## Planning Commission Staff Report

**SUBJECT:** P11-0899

**PURPOSE:** Application for Design Review approval to install a wireless facility consisting of a 55-foot tall monopine and related wireless equipment

To: Jenny Soo, City of Pleasanton  
 From: Jonathan L. Kramer, Esq.   
 Date: June 27, 2013  
 RE: P11-0899 2126 Rheem Dr. (AT&T Wireless)

Figure 1: Example of antennas extending beyond the branches  
(photo by J. Kramer)

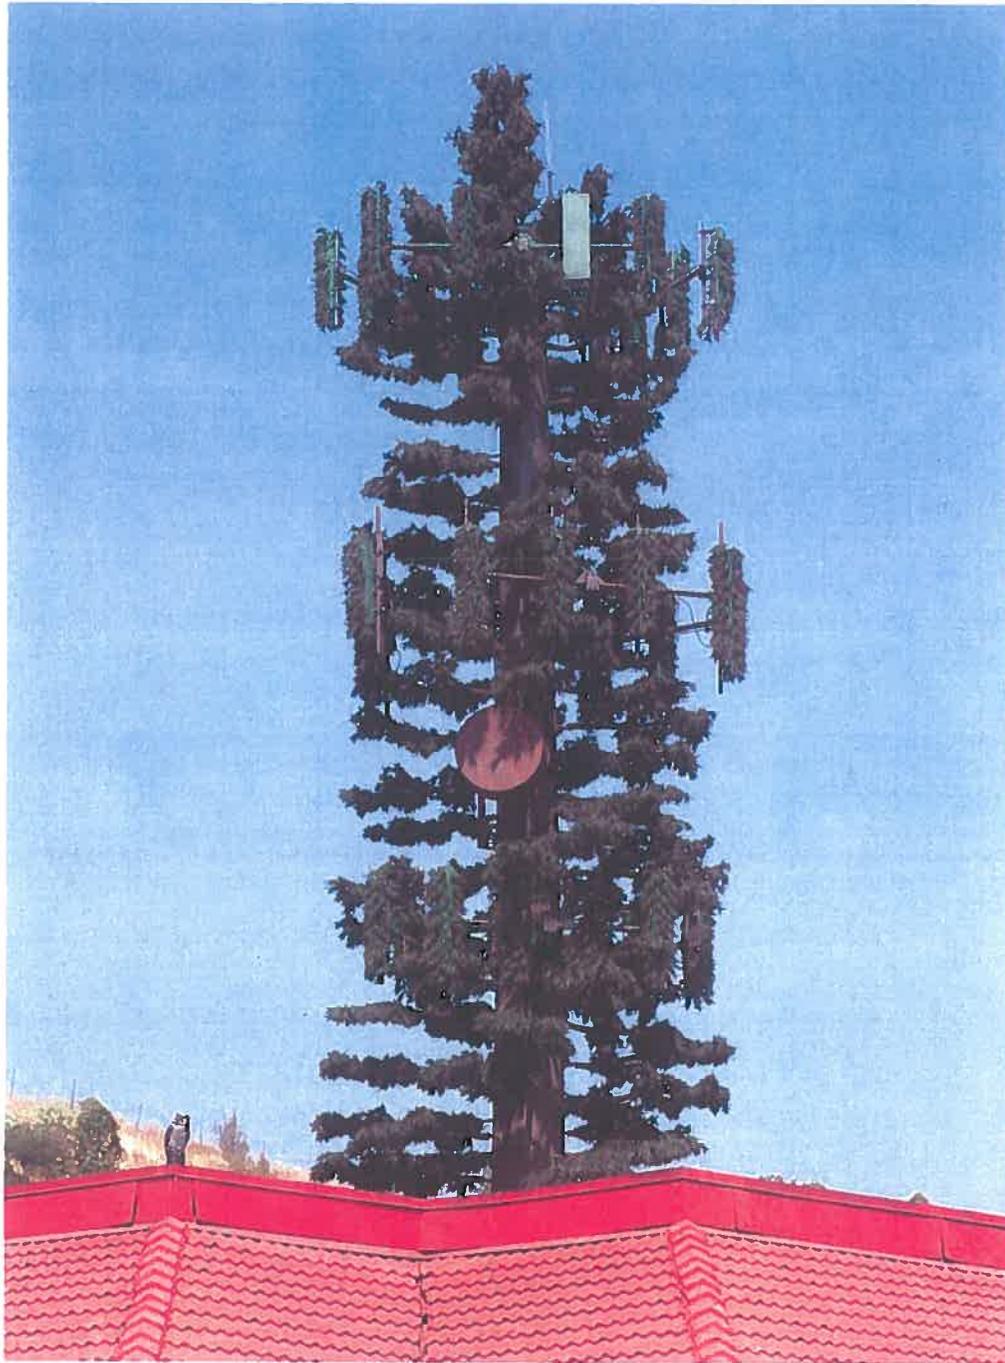
Enclosing the panel antennas within the canopy is desirable, and none should be permitted by design or construction to extend so as to protrude beyond the branch canopy. Failure to insist on a requirement to extend the branches past the antennas can result in the type of design shown in Figure 1, below.

I recommend that there be a minimum 12" of branches extending past all panel antennas and antenna-related equipment (such as the antenna actuators, RRUs and DC surge protectors) at each level of the monopine.

Figure 2: Partial bark cladding (Photo by J. Kramer).

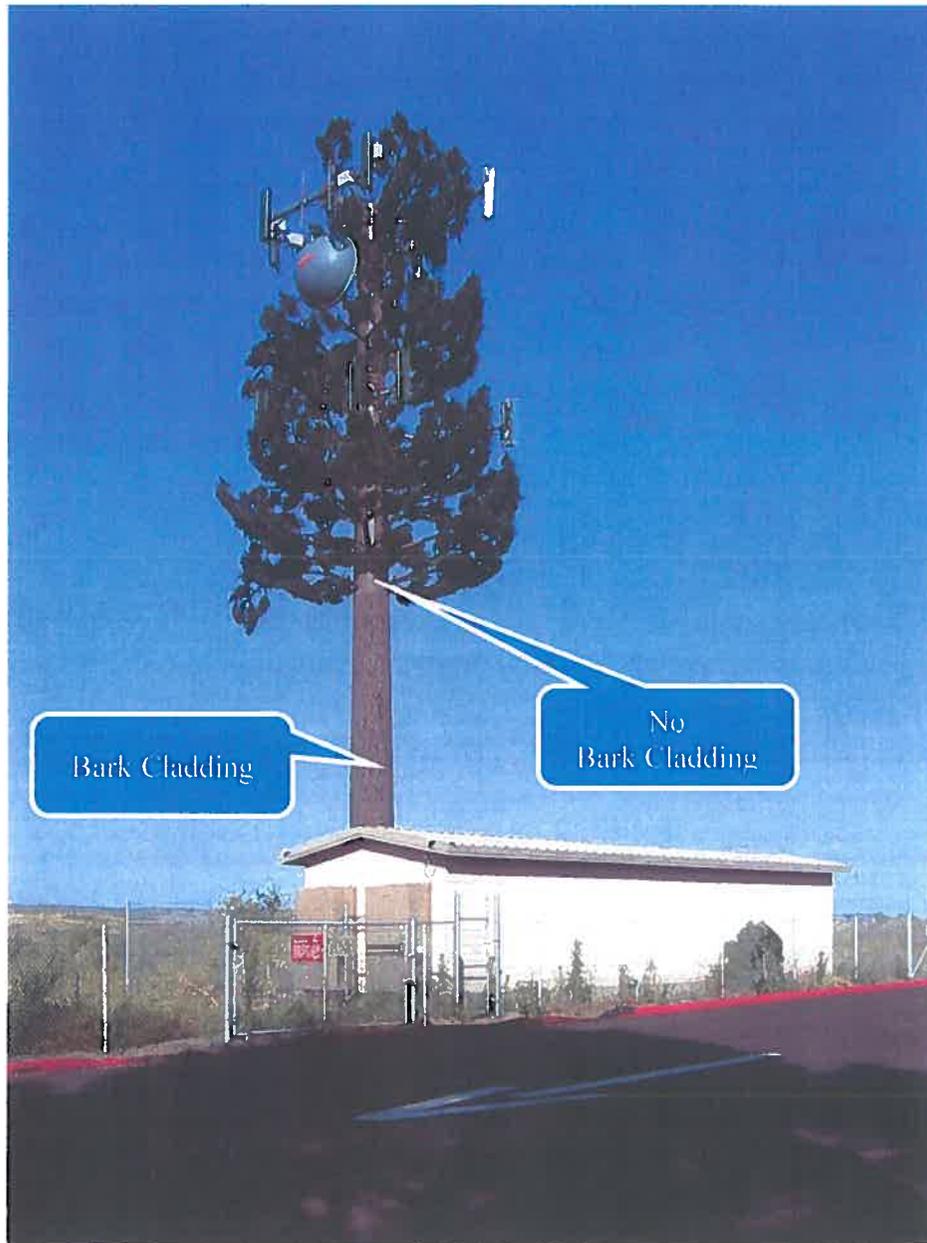
Figure 2, below, illustrates the visual discontinuity and heightened sun reflections from the flat surfaces that lack three dimensional bark cladding.

The planned design does not show that the monopine will use bark cladding from top to bottom and on all branches. I recommend that full length bark cladding be a City requirement.
